100% REVIEW SUBMITTAL NOT FOR CONSTRUCTION

PROJECT NAME: SOUTH HILL BUILDING & TECHNOLOGY CENTER PARKING EXPANSION PUYALLUP, WA

GENERAL NOTES, LEGEND & ABBREVIATIONS

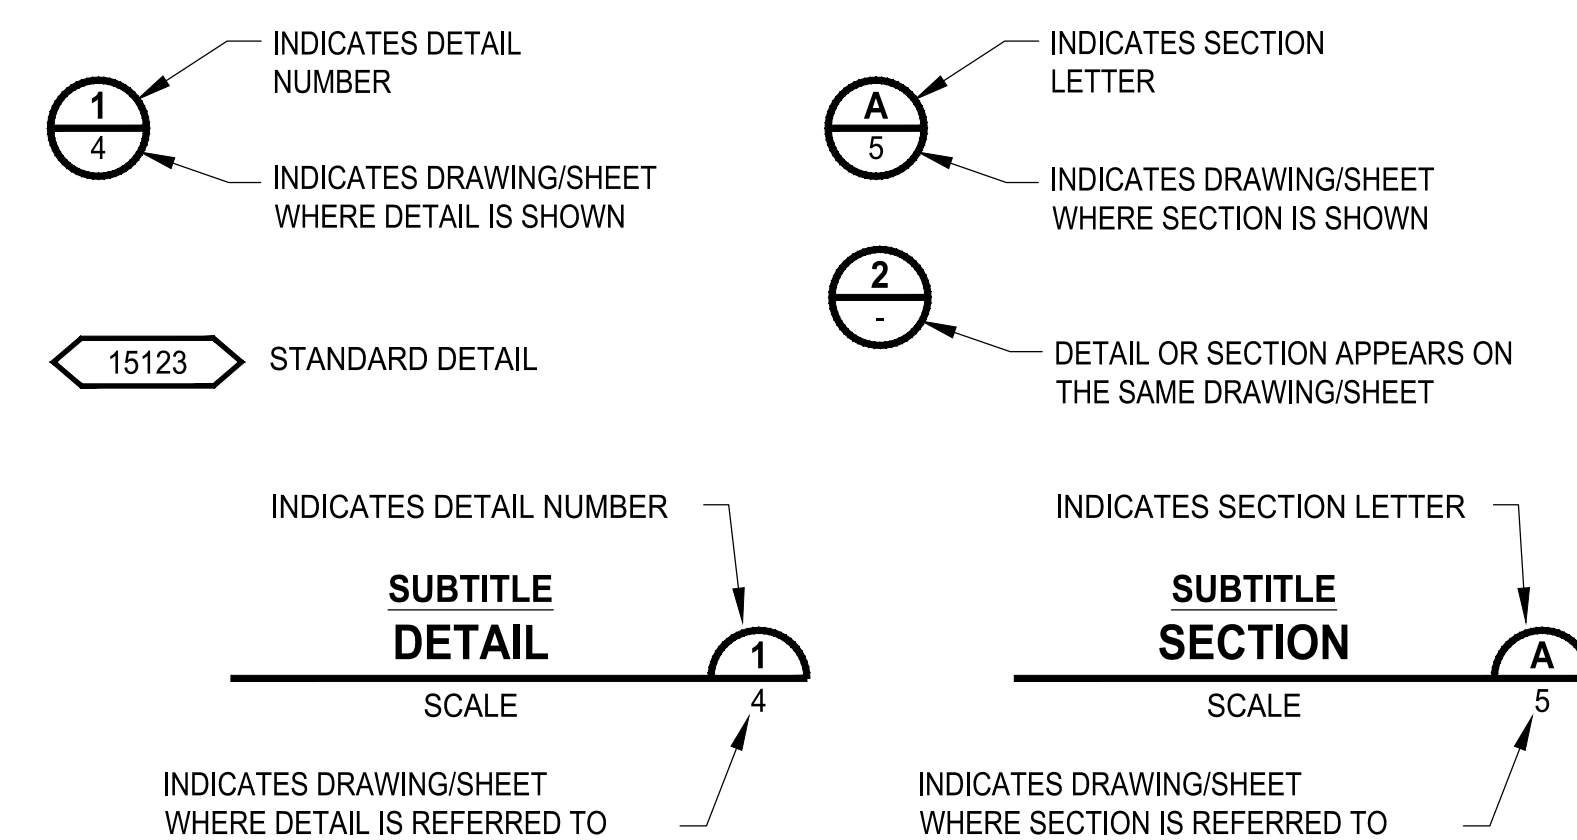
Add the following: City Standard STORMWATER NOTES (CS Section 207) City Standard WATER SYSTEM NOTES (CS Section 304) City Standard GRADING, EROSION AND SEDIMENTATION CONTROL NOTES (CS Section 505)

DEMOLITION, TESC, CLEARING & GRUBBING COMPOSITE PLAN

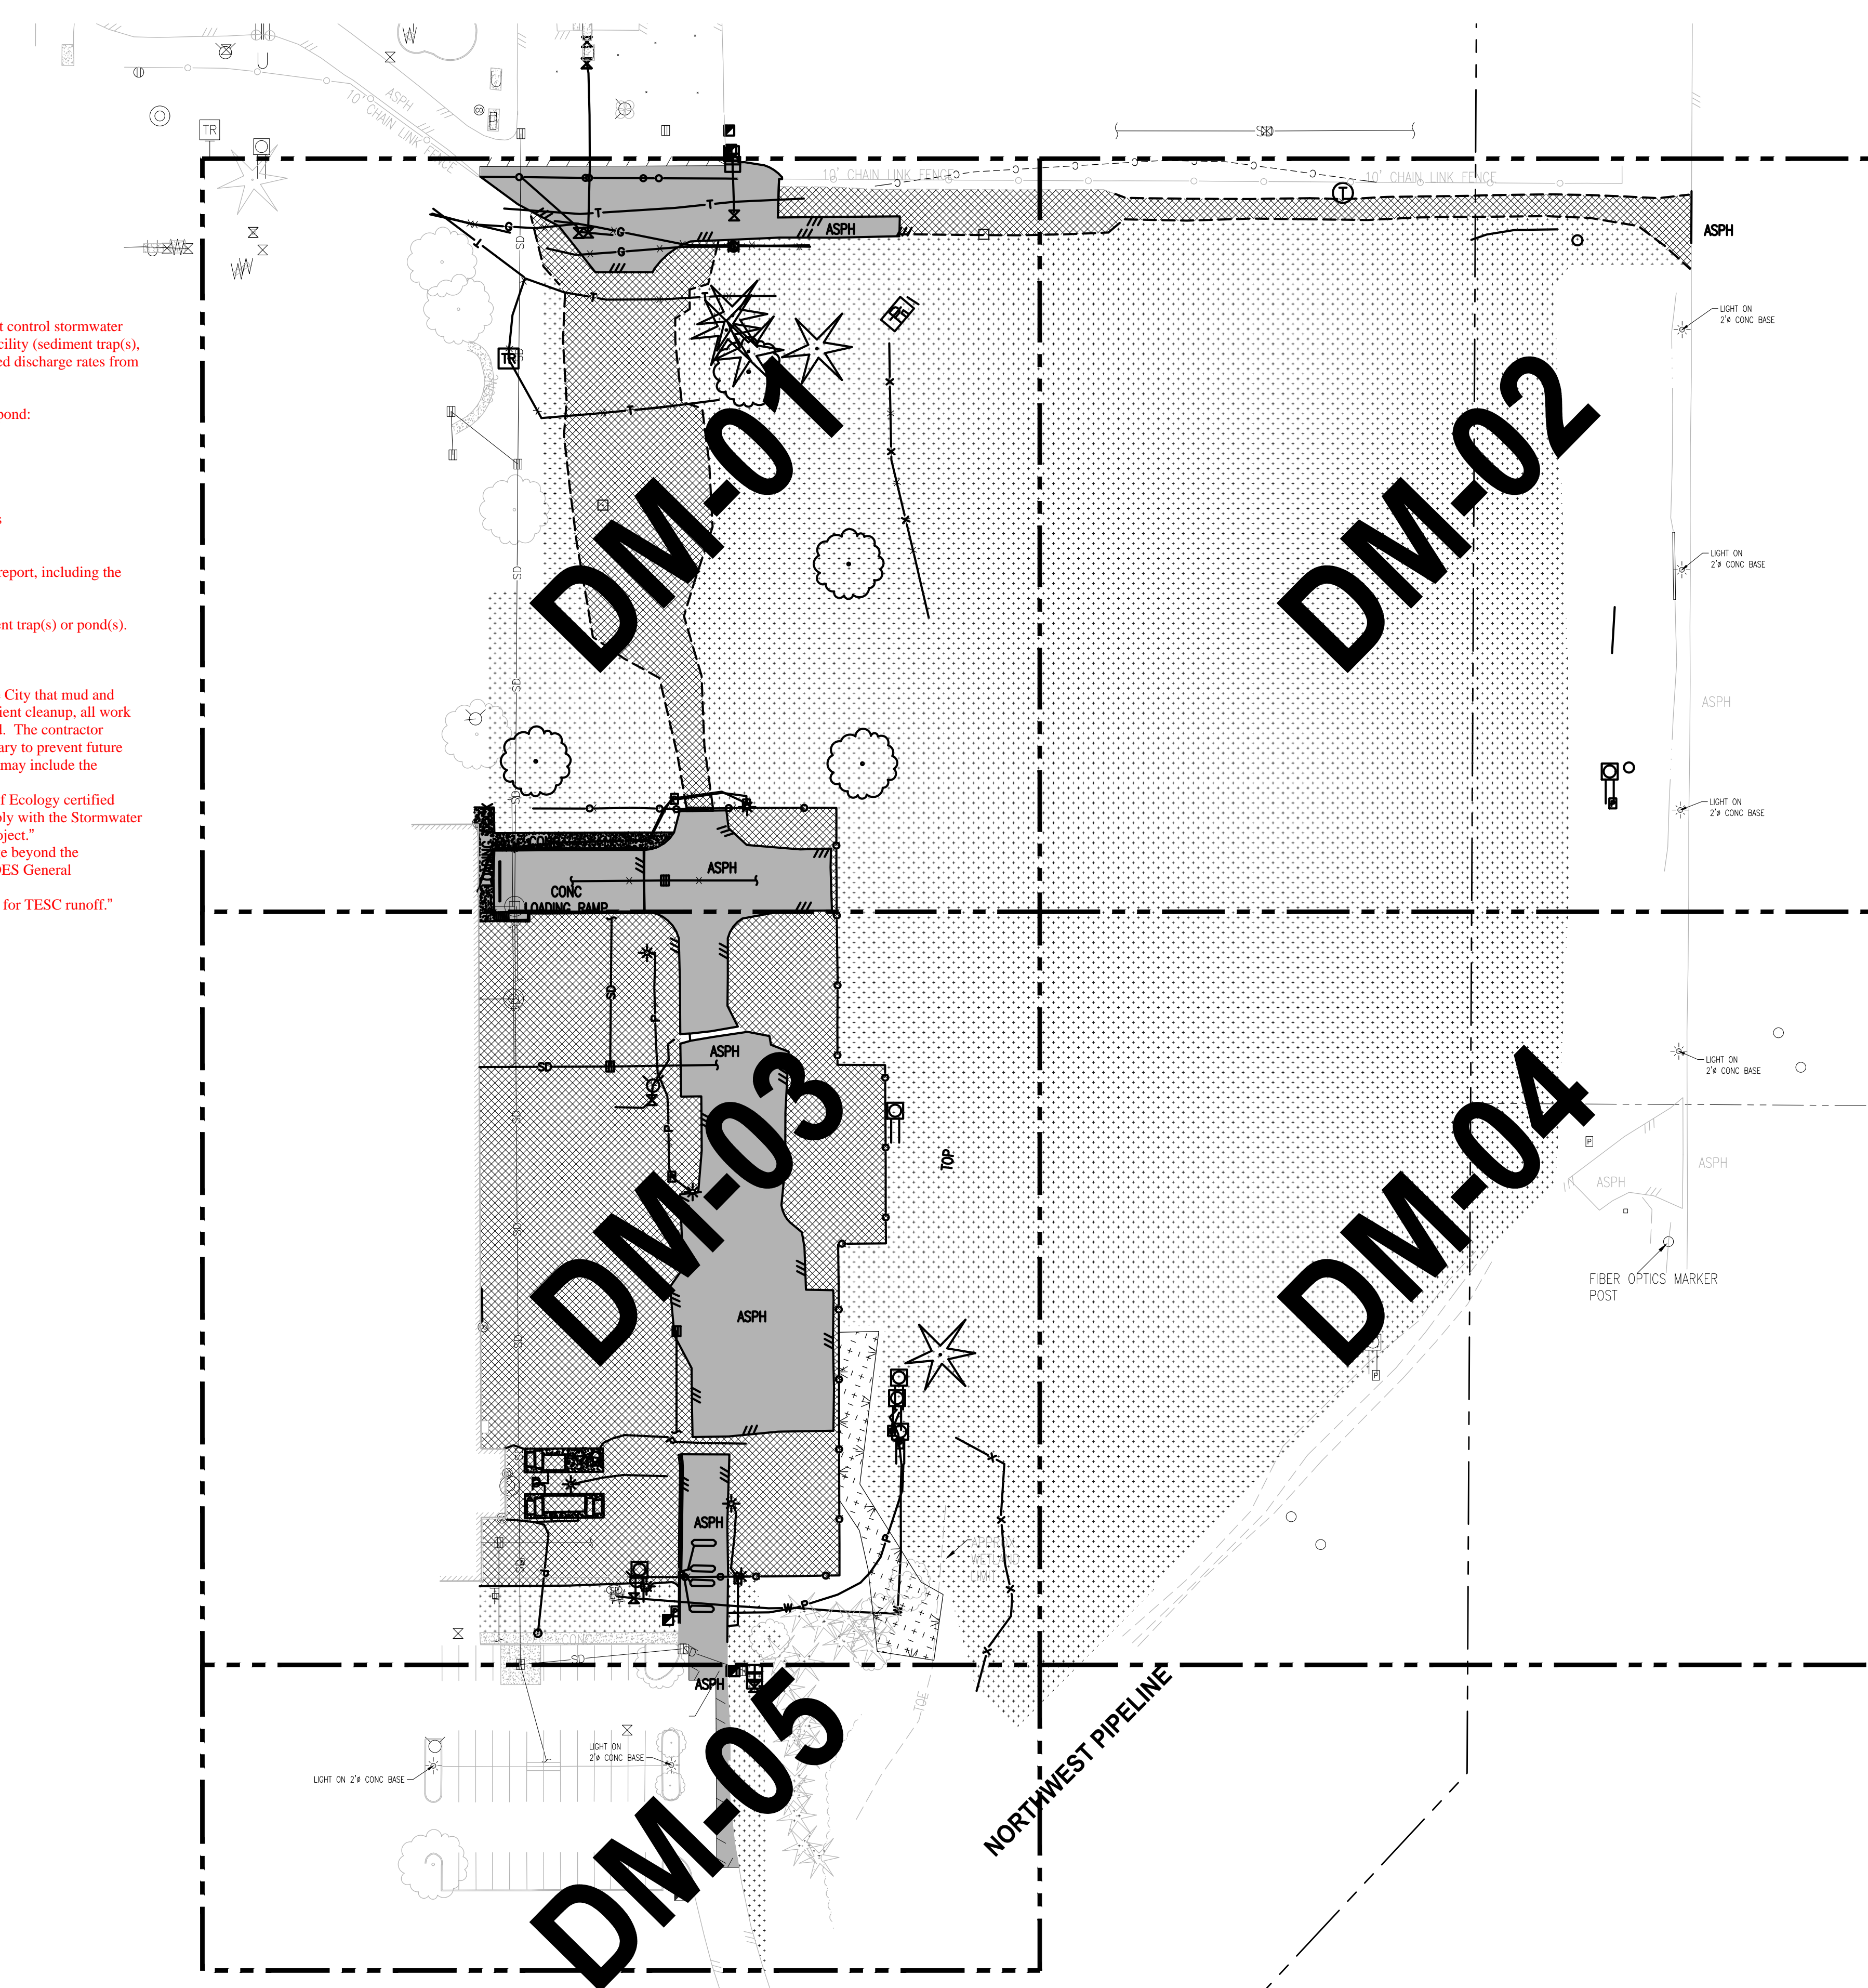
Per Ecology, projects subject to MR7 Flow Control must control stormwater release rates during construction. Provide a sediment facility (sediment trap(s), sediment pond(s), Baker Tank) sized for the predeveloped discharge rates from 1/2-2yr flow thru the 10-yr flow.

Provide construction information for any sediment trap/pond:
 -Identify contour lines.
 -Provide typical cross-section
 -Callout bottom area size
 -Callout top area size
 -Callout minimum volume.
 -Identify outlet and indicate where the discharge goes
 -Identify energy dissipation for inlet

Include sediment trap/pond sizing calculations in storm report, including the dewatering device and riser if used.

Callout interceptor swales to convey water to the sediment trap(s) or pond(s). Show cross-section detail on plans.

Add the following notes:
 -"At any time during construction it is determined by the City that mud and debris are being tracked onto public streets with insufficient cleanup, all work shall cease on the project until this condition is corrected. The contractor and/or the owner shall immediately take all steps necessary to prevent future tracking of mud and debris into the public ROW, which may include the installation of a wheel wash facility on-site."
 -"Contractor shall designate a Washington Department of Ecology certified erosion and sediment control leadperson, and shall comply with the Stormwater Pollution Prevention Plan (SWPPP) prepared for this project."
 -"Sediment-laden runoff shall not be allowed to discharge beyond the construction limits in accordance with the Project's NPDES General Stormwater Permit."
 -"Any permanent infiltration system shall not be utilized for TESC runoff."

Provide Construction Sequence per CS Section 501.6

DRAWING NO. 14 OF 70 DM-03

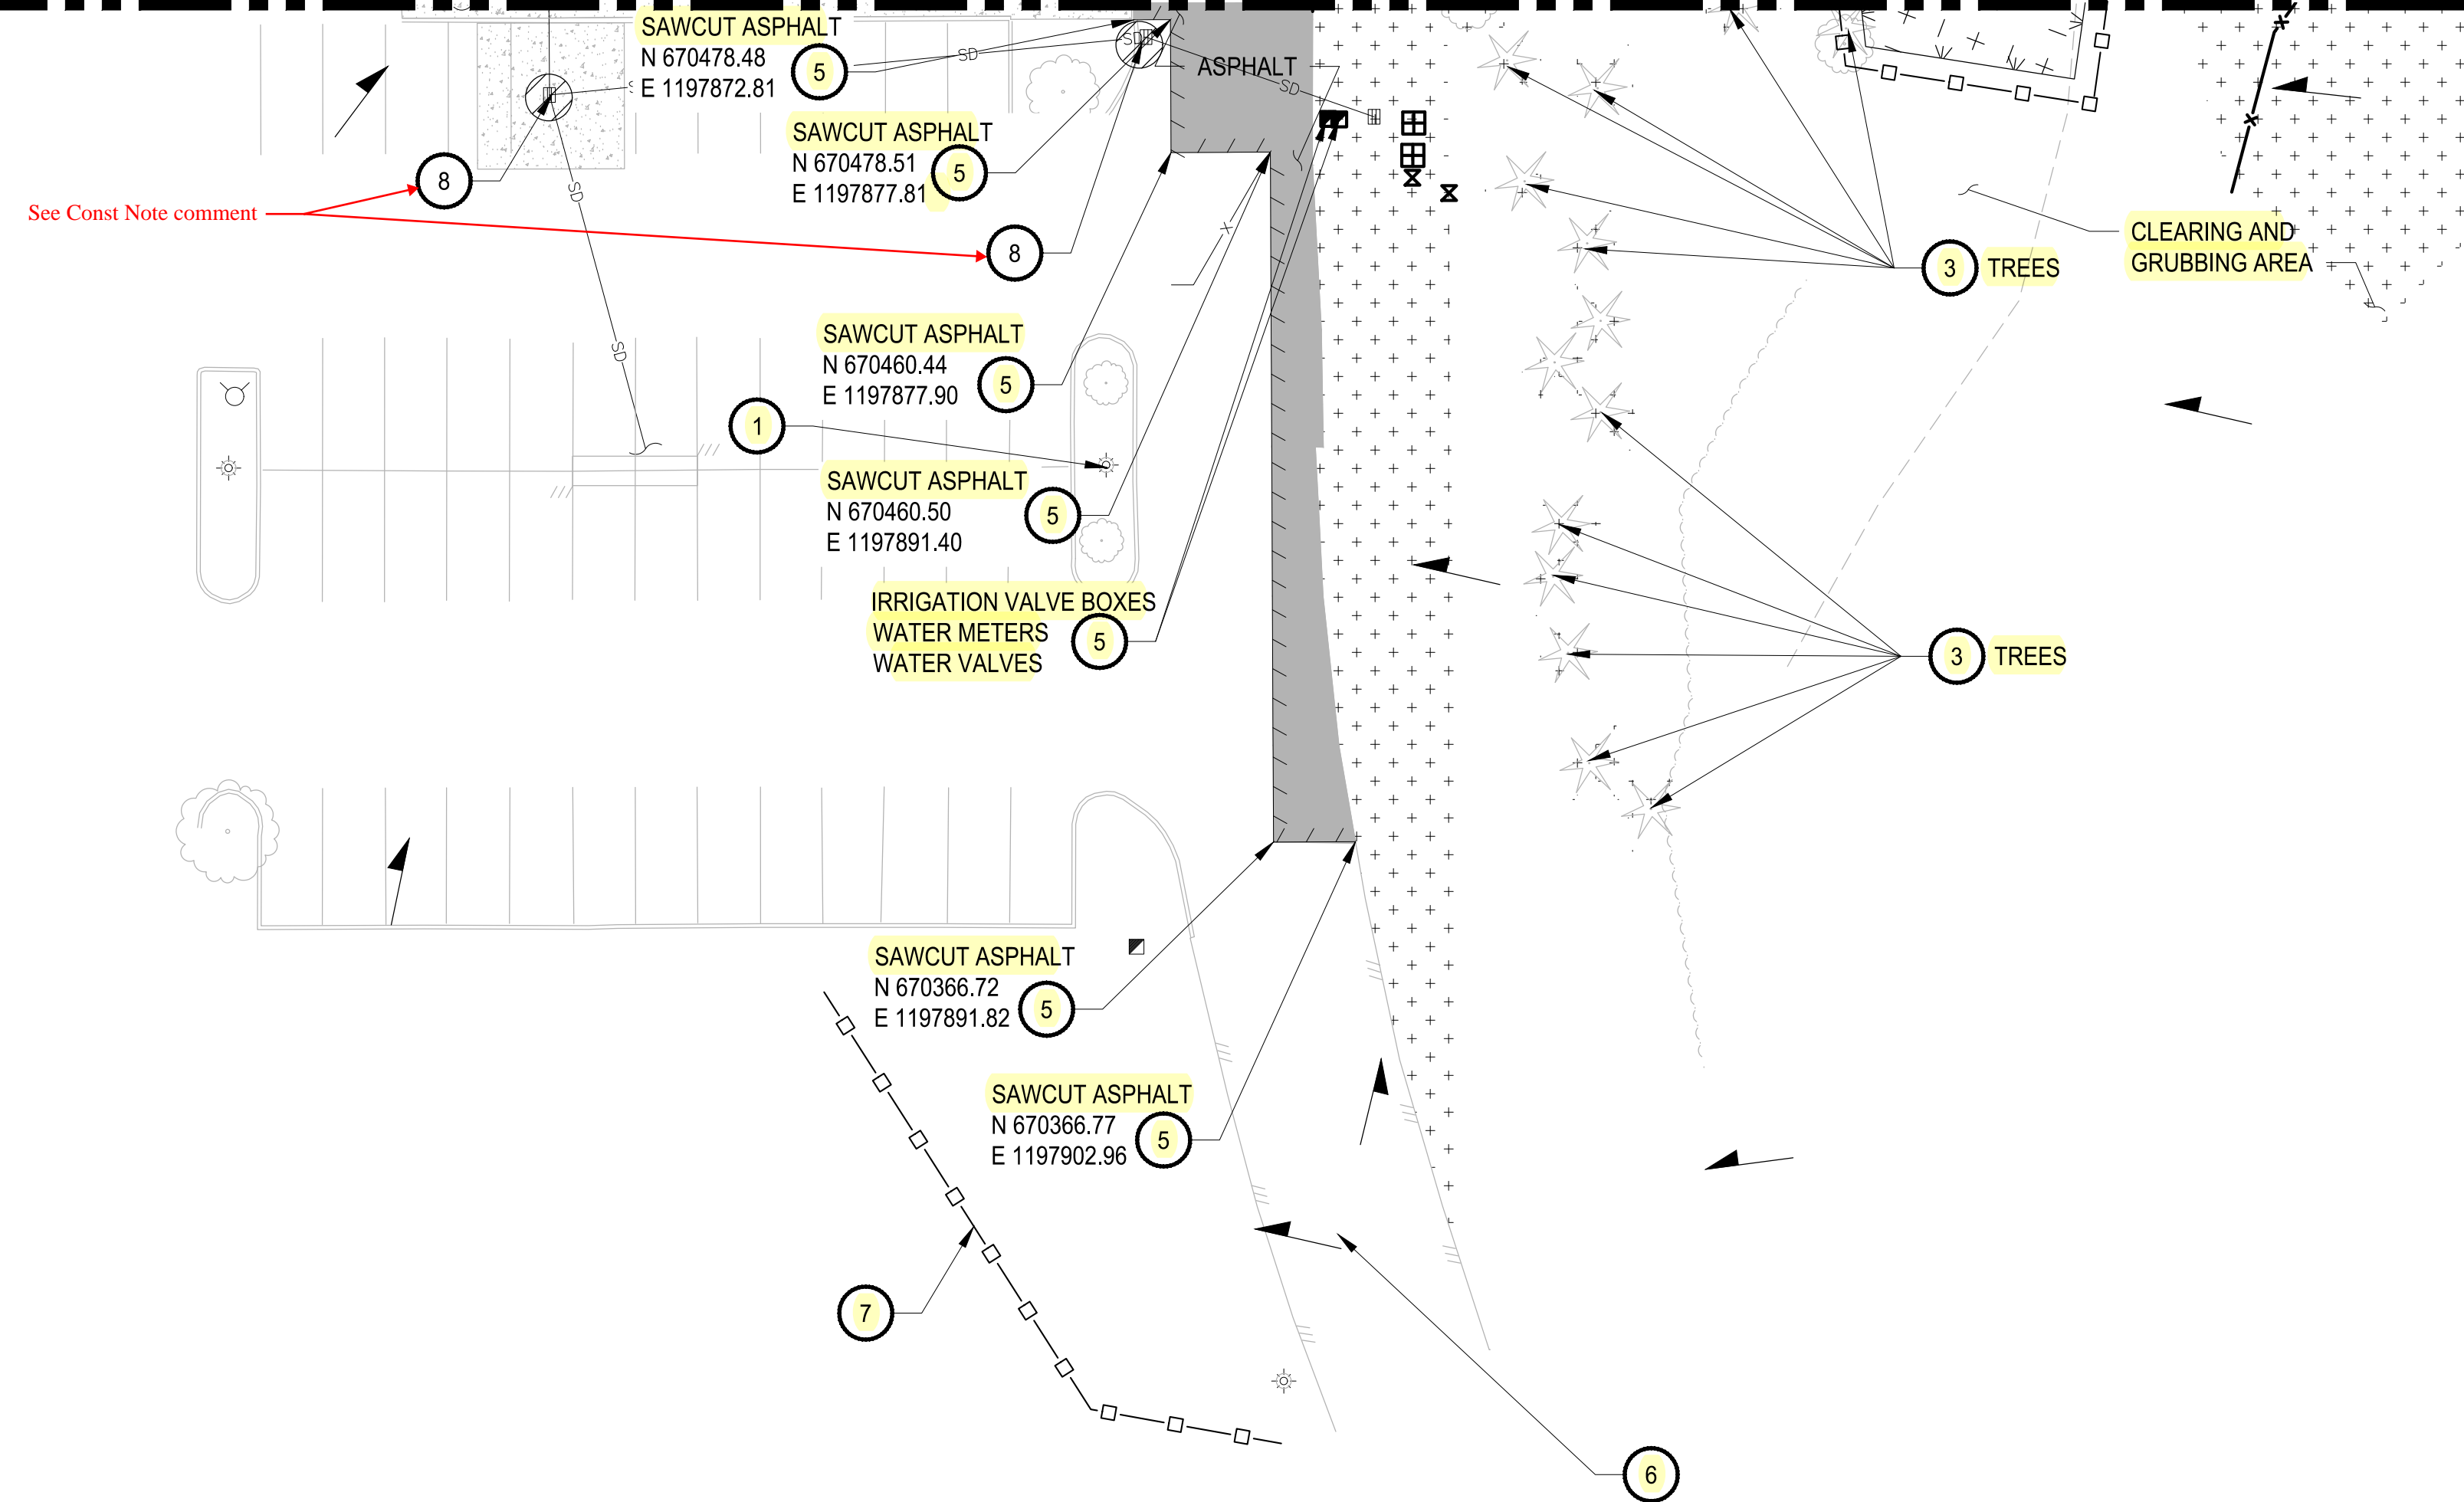
Verify...is this a roof drain?

NOTE: Max. overland flow tributary to any Silt Fence is 100-ft. Revise TESC plan accordingly. See comments Sheet DM00

Clarify...isn't the PIV and FH serving the existing building? If so, where are these components being relocated? If relocated, callout new location and connection req's (valves; piping; thrust blocks; etc)

Clarify...is this the DDCVA and vault? Is it currently serving the building? If so, how is the building being protected?
